RE: 2401 Washington CDR submission

We are pleased to submit the CDR presentation for our project at 2401 Washington Ave. This project includes 113 units and more than 100,000 SF of building area.

# COMPLETE STREETS HANDBOOK CHECKLIST

**ZONING PLAN**  
SCALE: 1" = 40'-0"

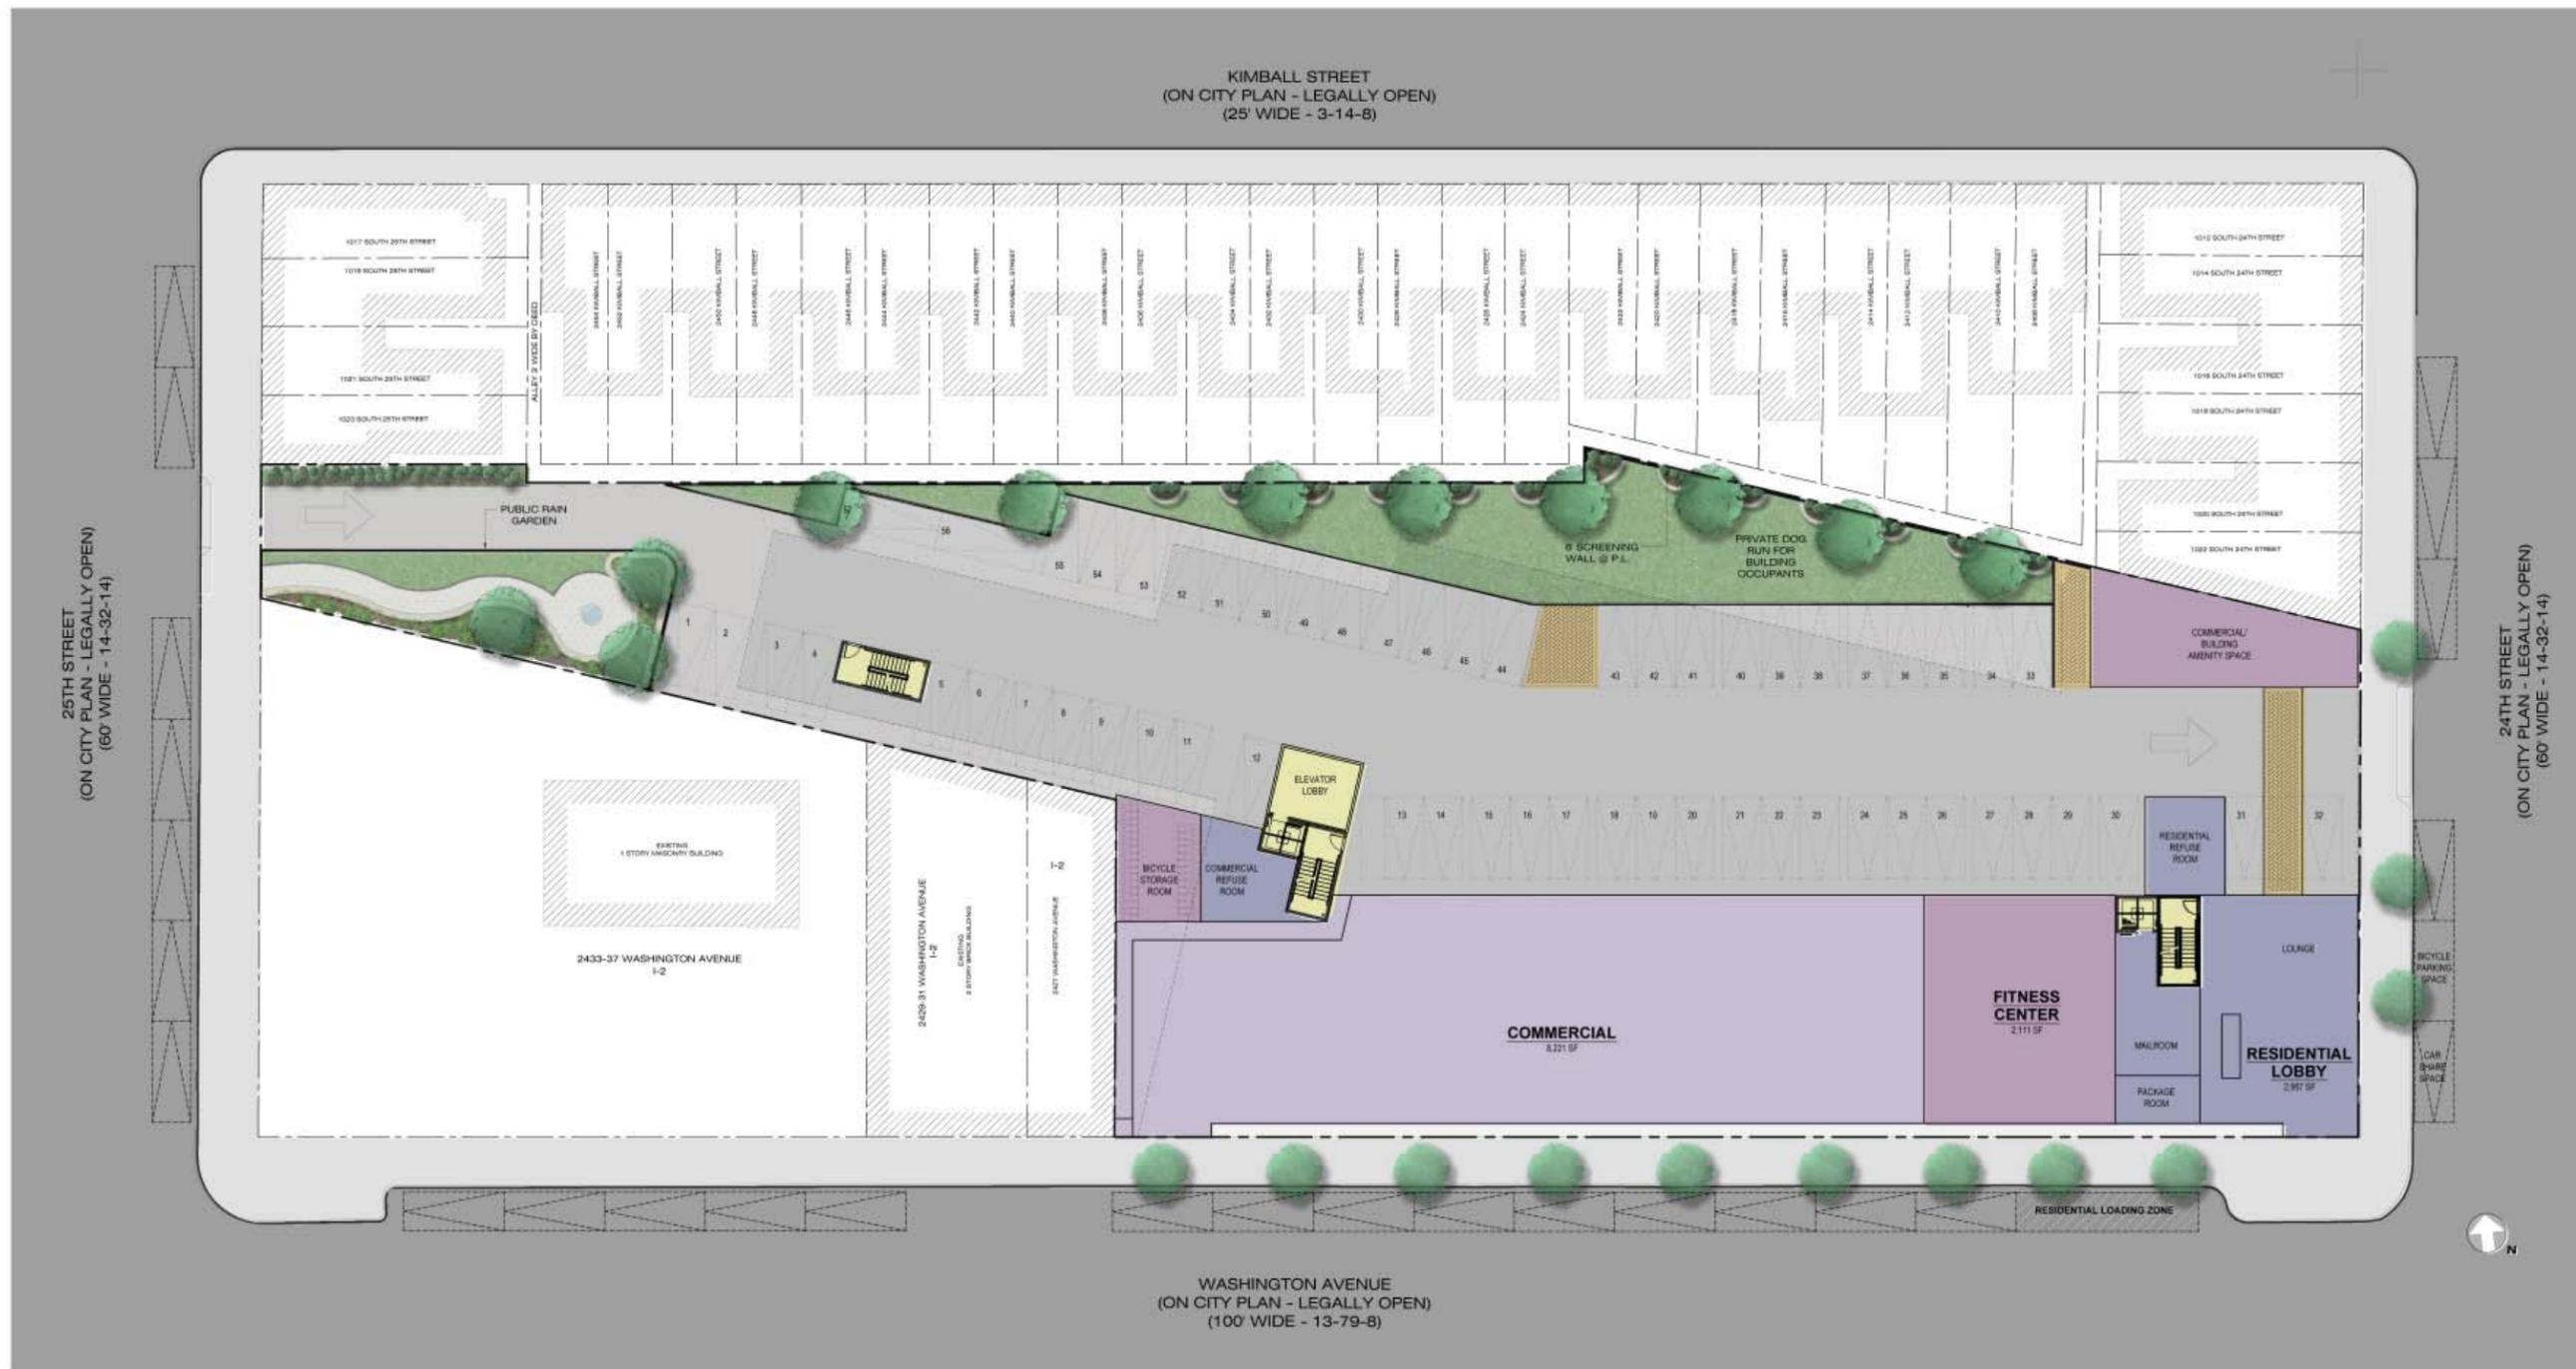
Question 14: The driveway curb cut on 25<sup>th</sup> Street frontage is incorrectly listed. On the plans it is 24'.

Question 24. The plan lists the bicycle parking as 57 spaces, not 53. Which is correct? Where are the on-street bicycle parking spaces? They do not appear on the plan. Why is there an in-street bicycle parking corral here? That feature is typically included only in a location with demonstrated high bicycle demand and a lack of on-street or in-building parking. The Streets Department will request removal of that item. Instead, consider placing U racks on-street on Washington Avenue, parallel to the curb.

Question 35. There is a proposed loading zone on the plan on Washington Avenue, contrary to the answer of No here. Instead, consider rearranging internal parking to accommodate residential and commercial loading in the parking lot.
